ISSUE: Revisions to Previously Approved Plans (alterations)

APPLICANT: Steven and Patricia Kelmar

LOCATION: Old and Historic Alexandria District
609 South Lee Street

STAFF RECOMMENDATION: Staff recommends approval of the proposed alterations, with the condition that the applicant continue to work with BAR staff to refine or modify the pedimented parapet wall and the cornice area on the second floor of the projecting bay.

Figure 3: Current application (Alternative A)

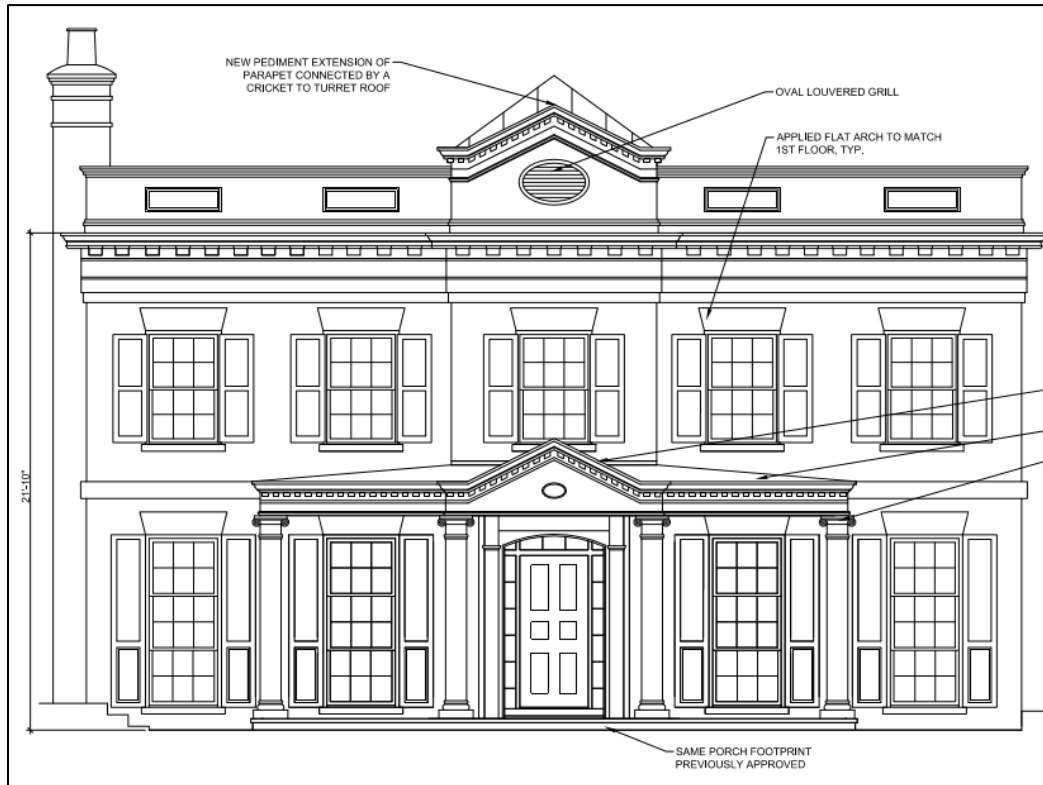
Staff supports the addition of more classical details, such as the applied jack arches, new classical entablature and 1' diameter Ionic style classical columns (Figure 3). However, the addition of the pedimented cornice on the parapet wall above the main building cornice is awkward and the proportions are somewhat less successful than the façade previously-approved by the BAR (Figure 1).

In recent discussions between the applicant and staff, it was suggested that the current application drawing (Alternative A in Figure 3) showing the overlay of a pediment in front of the pyramidal roof of the turret was awkward and the pediment on the porch seemed visually unsupported. However, the addition of the pediment form at the second floor of the house does draw the eye up and, in combination with the pediment at the porch, reinforces the hierarchy of the façade at the entrance.

The applicant has responded with an alternative sketch (Alternative B) which staff believes is a further improvement. Figure 4 integrates a pediment in the revised entablature of the building above. Lowering the pediment on the building removes it from the conflict with the pyramidal roof of the turret shown in Alternative A. The bolder single brackets of Alternative B are a classical, rather than Victorian form, and the bolder modillions, or dentils, are more appropriate for the Colonial Revival. However, staff recommends that the entablature be the taller, classical height of the one shown in Alternative A. Finally, staff recommends that the frieze below the cornice of the porch be carried across the entry bay below the pediment to provide some visual support.

**PROPOSED MINOR AMENDMENT TO BAR APPROVAL
FRONT ELEVATION 609 S. LEE STREET**

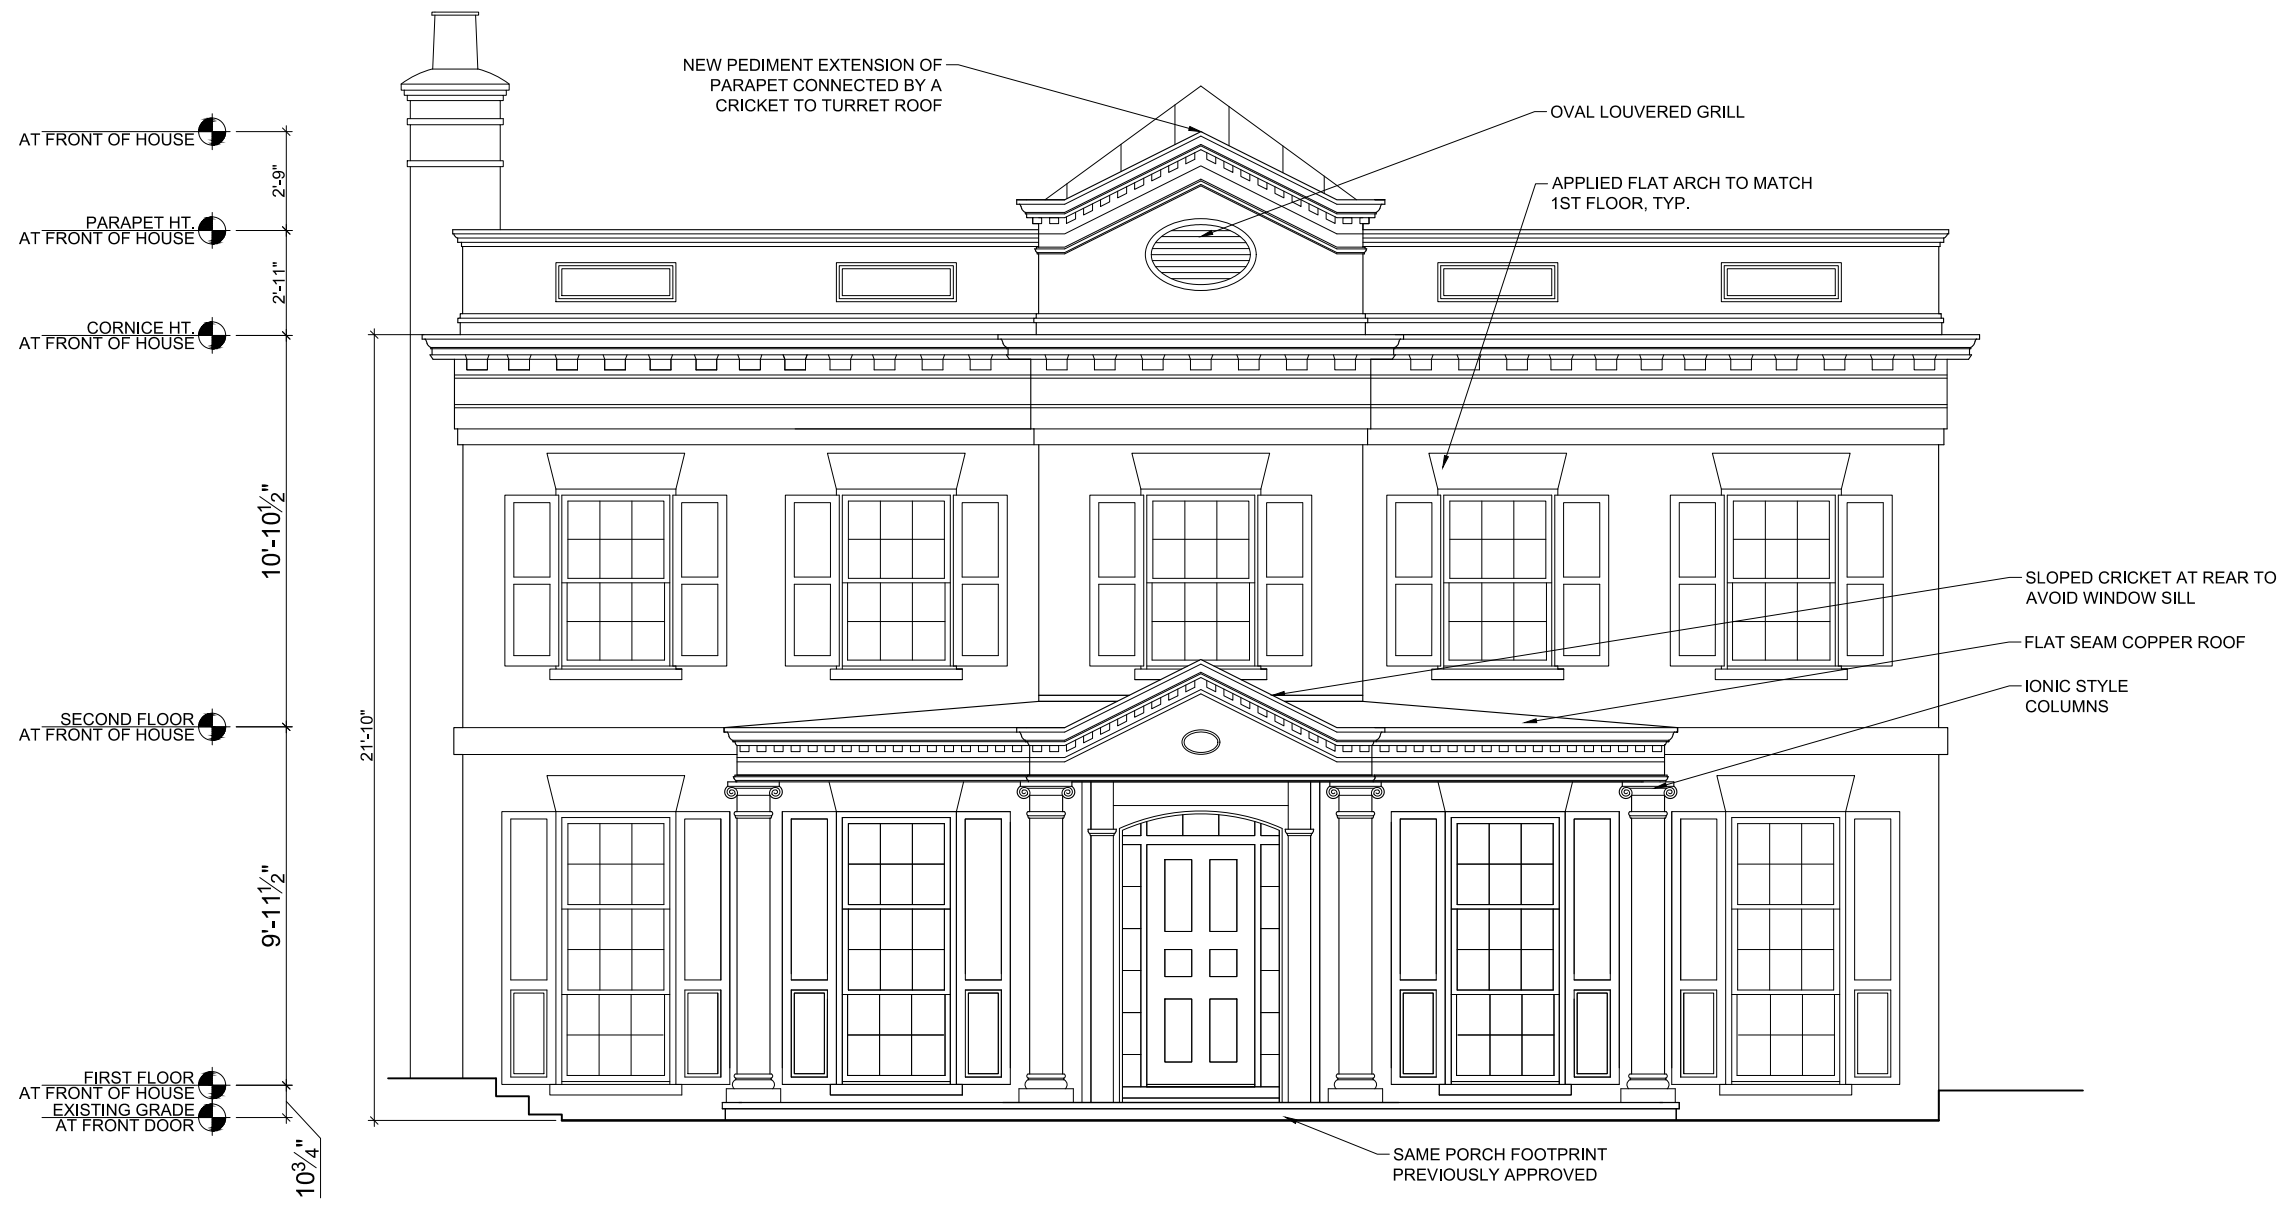
The proposed changes included in the Minor Amendment are as follow:

- 1. Replacing the deteriorated cornice and frieze. The Victorian brackets are removed, and a simpler pattern of dentils or modillions fill out the cornice.*

- 2. Redesign the front porch in a classical style, rather than the previously approved complex Victorian posts and decorations. The columns may be Ionic or Tuscan, based on the owner's choice. The raised pediment at the center bay eliminates the need for a gutter and adds height to the composition. It will be attached by a slanted cricket to avoid the window behind.*

- 3. The central portion of the recently added parapet would be modified to include a similar pediment to the front porch, and an oval louver. This element is placed in front of the turret, and attached by a cricket. The turret was an unsuccessful addition to the house, perhaps watered down from the original concept of a low mansard that was abandoned during early design phase. As the copper ages, I believe the turret will be almost unnoticeable.*

**ARCHITECT TO DISCUSS
DETAILS WITH
BAR STAFF AS DESIGN
DEVELOPS FURTHER**
